Mercedes-Benz

Campaign No. 2020040001, August 2022

SUBJECT: **Model 906 (Sprinter)**
Model Year 2016
Modification to the emissions control system

Emissions Campaign 2020040001

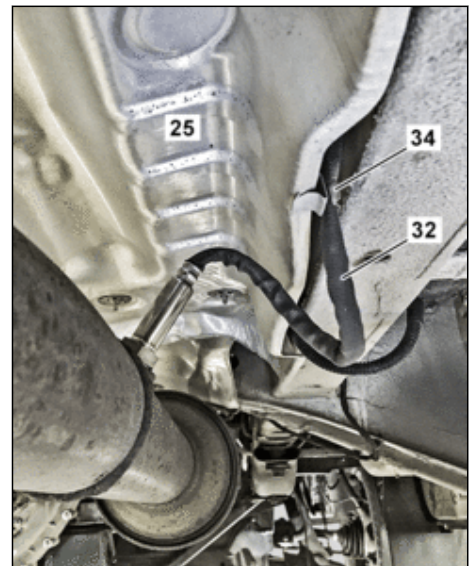
The layout schematic of the harness (32) has changed on account of the changed position of the NO_x sensor downstream of the SCR catalytic converter (4).
